REPORT
PROJECT: 137404.6.04.03

DESIGN BRIEF
1515 EARL ARMSTRONG PLAZA
RIVERSIDE SOUTH

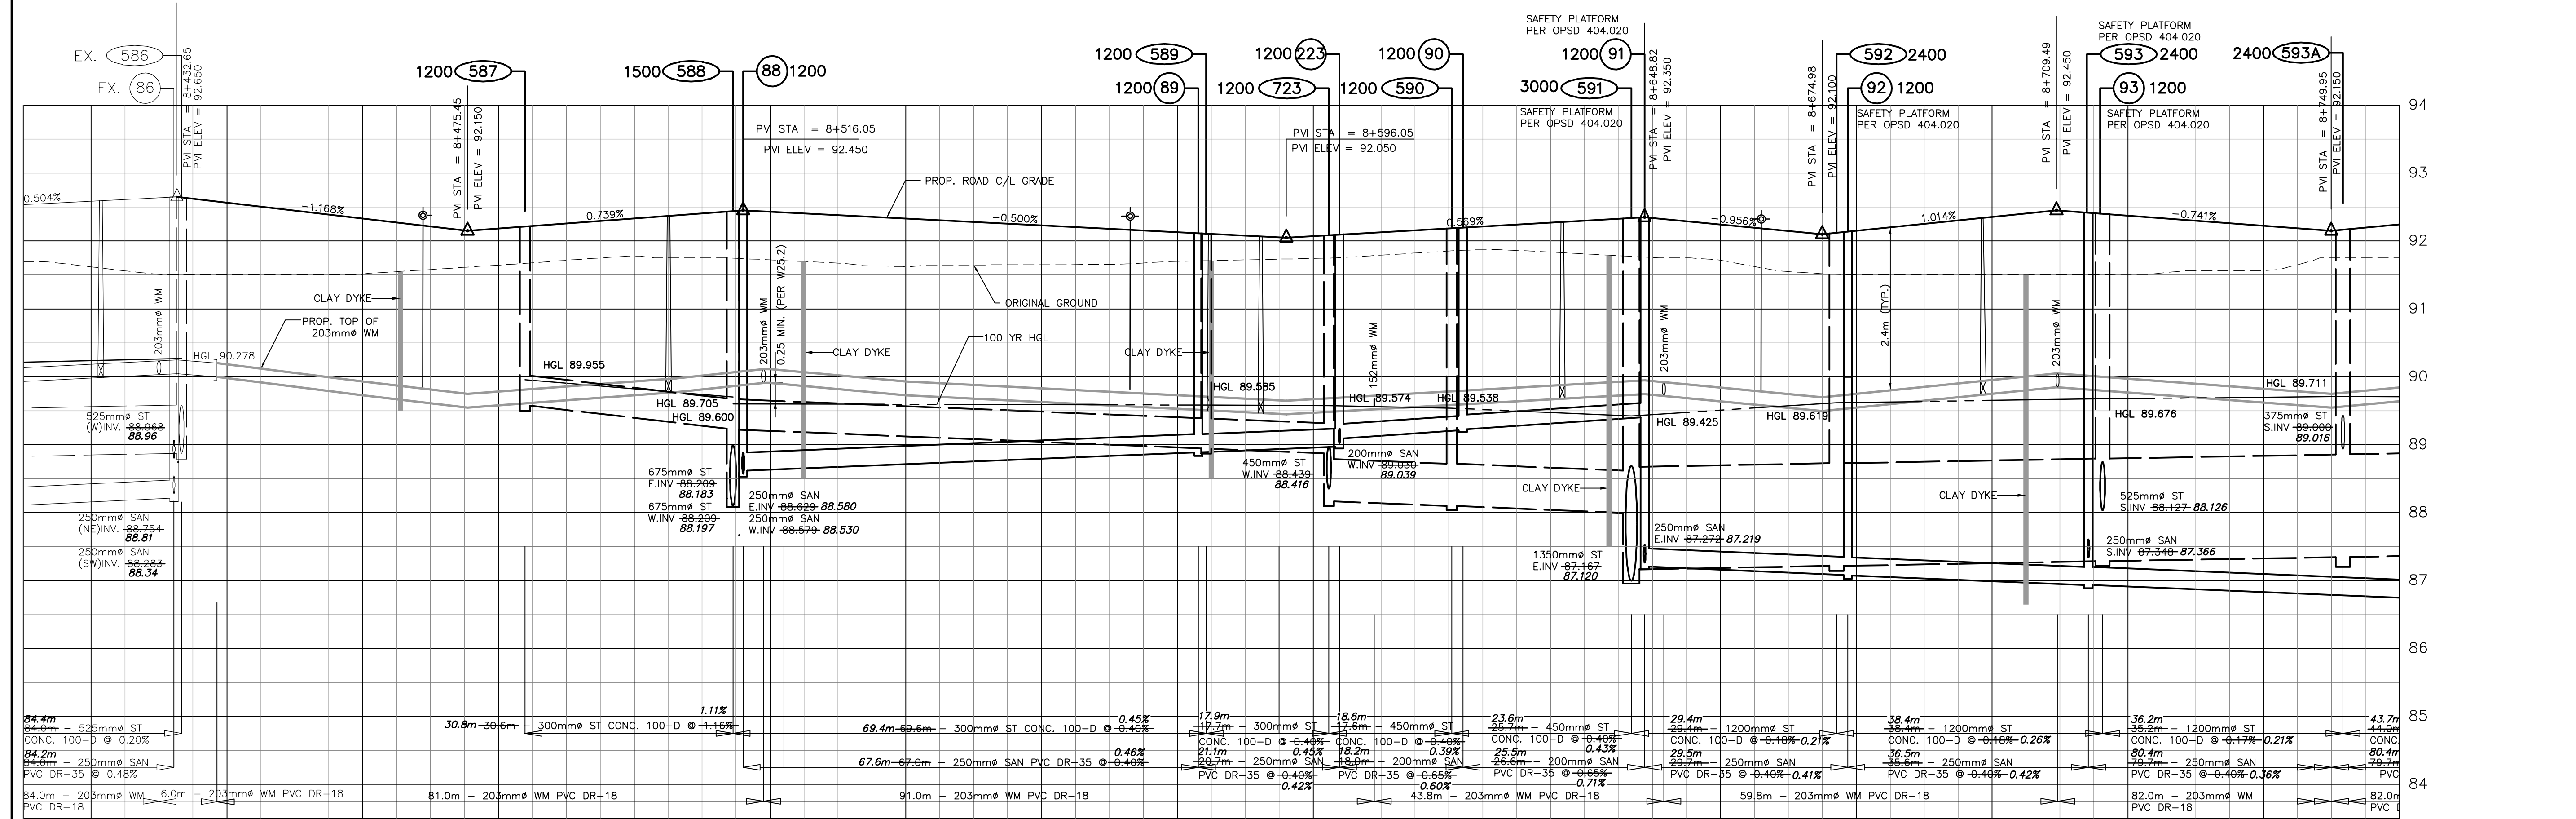
NO.	REVISION	DATE
9	AS CONSTRUCTED INFORMATION ADDED	09/06/08
8	SIDEWALK ADDED ON ROYAL FERN WAY	15/06/07
7	RE-ISSUED FOR TENDER	23/03/07
6	ISSUED FOR CONSTRUCTION PART A & B	28/02/07
5	W/M SYSTEM REVISED FOR FUTURE CONVERSION TO HIGH PRESSURE LAYOUT MODIFICATIONS	16/01/07
4	REVISED PER CITY COMMENTS FOR MCE APPROVAL	14/12/06
3	REVISED TO SUIT PHASING AND MINOR LAYOUT MODIFICATIONS	22/09/06
2	REVISED LAYOUT - RESUBMISSION TO CITY FOR REVIEW	23/06/06
1	ISSUED FOR CITY REVIEW	28/02/06
